Environmental Impact Report for the
Belden Barns Farmstead and Winery Project
State Clearinghouse No. 2015092031

**Belden Barns Farmstead and Winery
Final Environmental Impact Report**

CHAPTER 1 INTRODUCTION

3.8-1	Noise Measurement and Modeling Locations	2-9
-------	--	-----

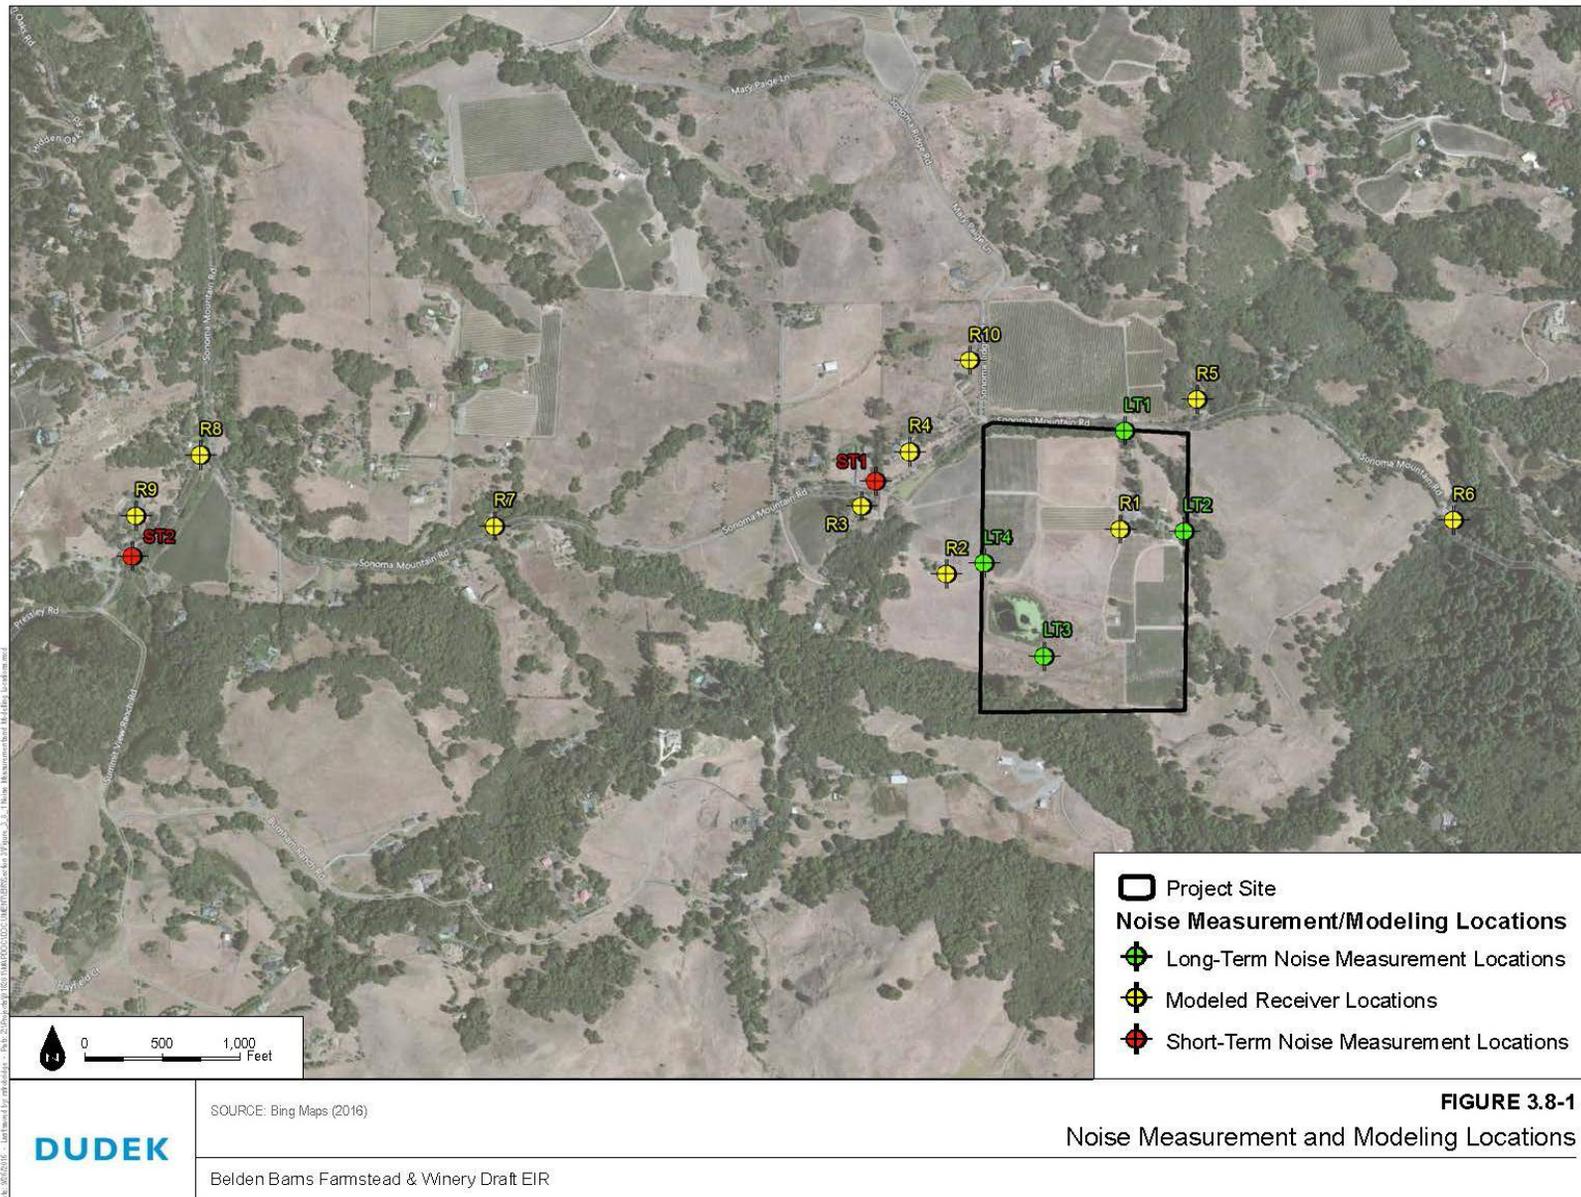
In addition, Figure 3.8-1 has been revised to more clearly identify the location of the measurement locations and is included at the end of this chapter.

Page 3.9-5 "Existing Traffic and Roadway Conditions" (Appendix 9)

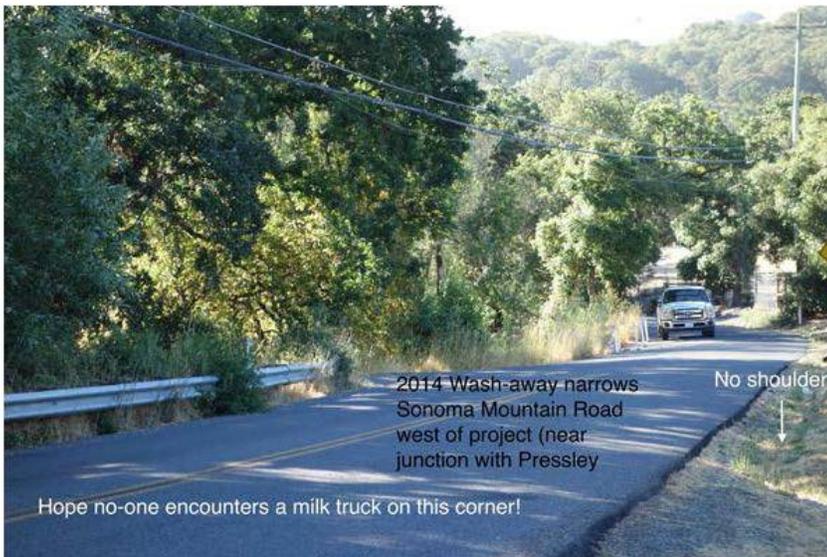
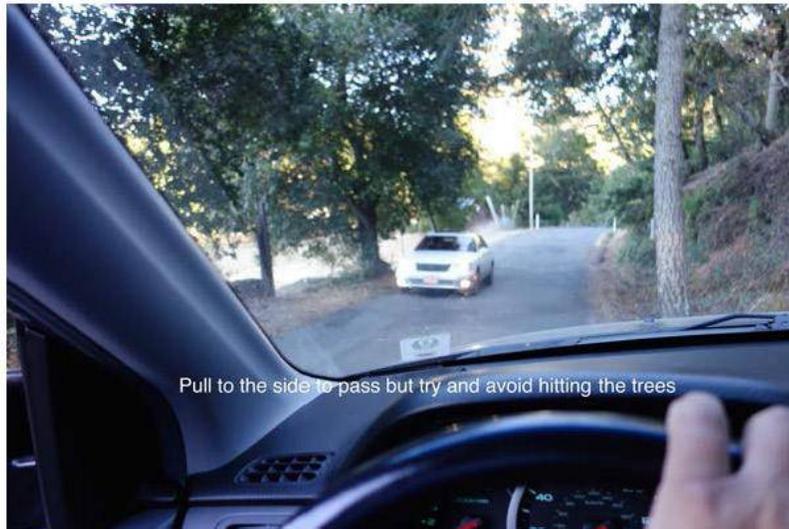
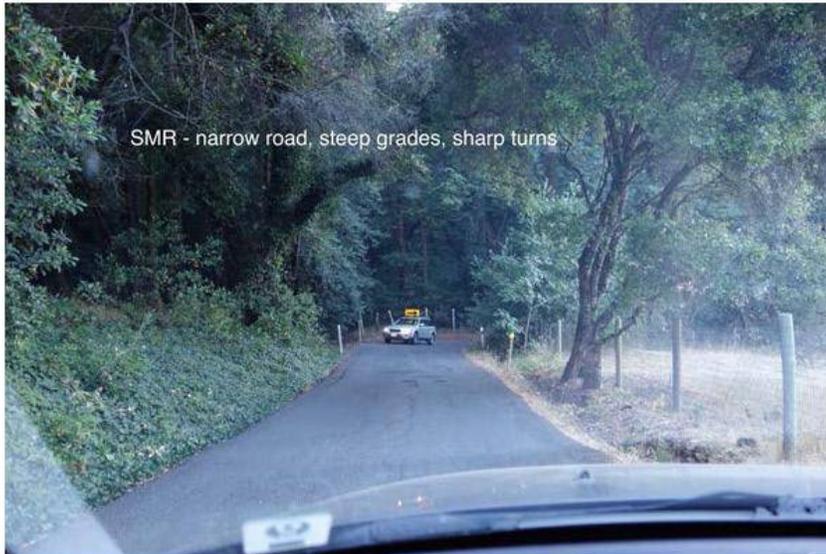
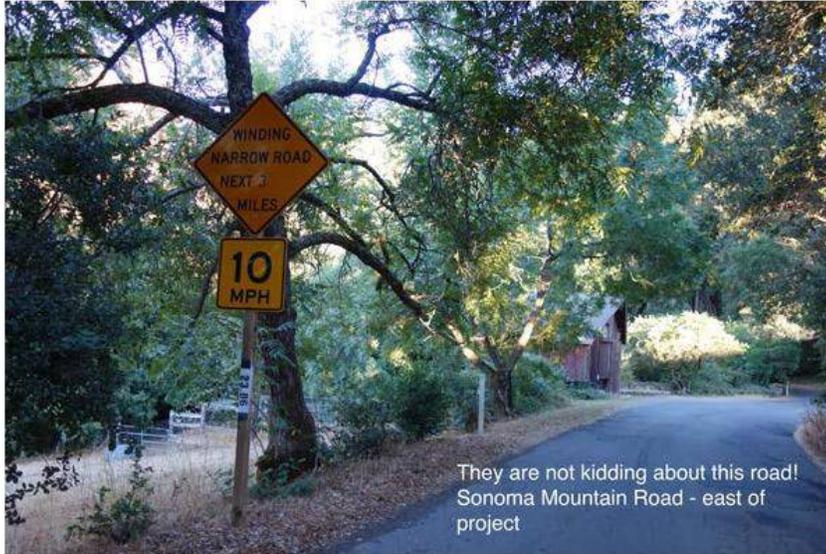
How does Sonoma Mountain Road look, to take on a projected increase in traffic between 21% on weekdays, to 27% weekend days and potentially 53% on Special Event days?
